## Service Info

# Crankshaft gear

### Note different pitches

Engine: 1.4 TSI

Figure 1: 559 0154 30/559 0154 31 – Timing chain KIT components

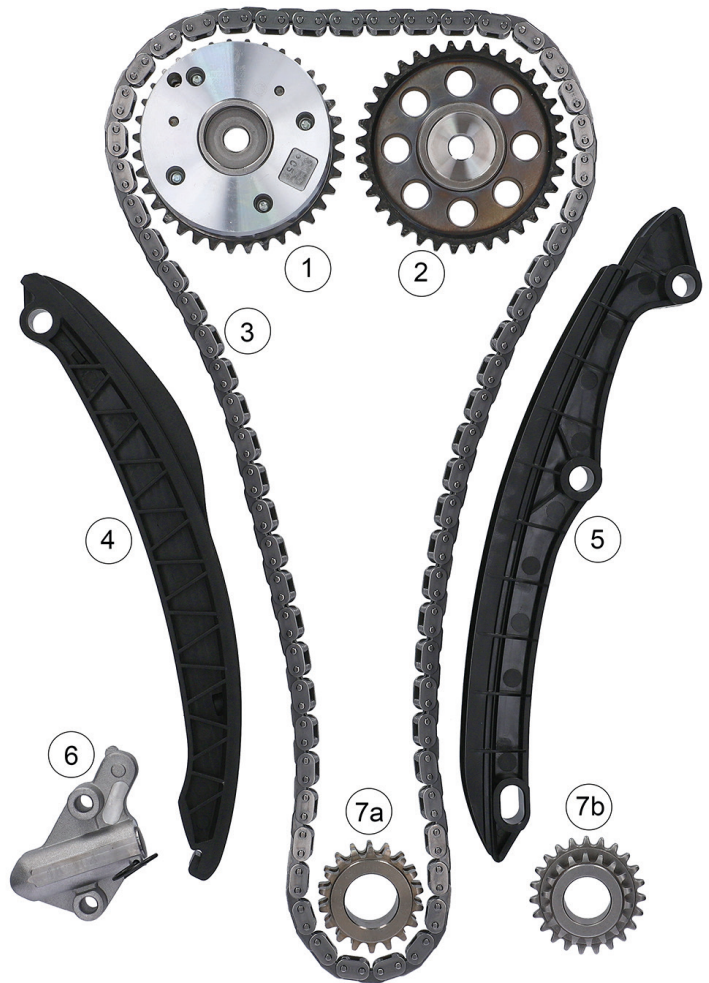
For the engine listed above, the crankshaft gear for the timing chain system is available in four different tooth pitches.

If a gear with pitch 18/19 or 23/19 is removed from the crankshaft, ALL components of the timing chain system must be replaced when installing the corresponding timing chain KIT (see table, page 1). Otherwise, when the engine is running, the altered number of teeth will change the timing settings.

The following arrangement must be used:

Crankshaft gear removed	Part number	Crankshaft gear to be installed
Pitch 18/18	559 0154 30	Pitch 18/18
Pitch 18/19	559 0154 30	Pitch 18/18
Pitch 23/18	559 0154 31	Pitch 23/18
Pitch 23/19	559 0154 31	Pitch 23/18

Figure 2: 559 0154 30/559 0154 31 - Timing chain KIT attachments

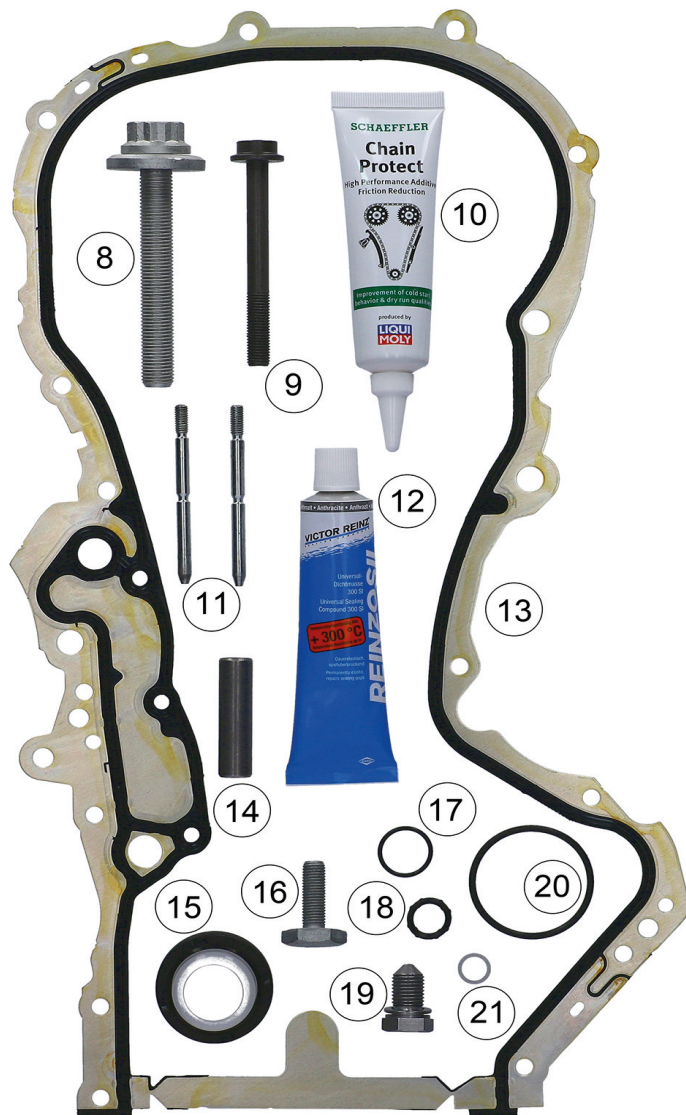
In addition, some engines with the engine code CAXA drive the oil pump not with a toothed chain but rather with a roller chain. In this case, the drive chain, the chain tensioner and the chain wheel of the oil pump must also be replaced.

The screw for the camshaft timer is an expansion screw with lefthand threads and may be used only once. Follow the vehicle manufacturer's installation instructions.

As an installation aid for mounting the timing system housing and the oil pan, guide pins are included in both timing chain KITS. Screw them into the cylinder head and cylinder block, respectively.
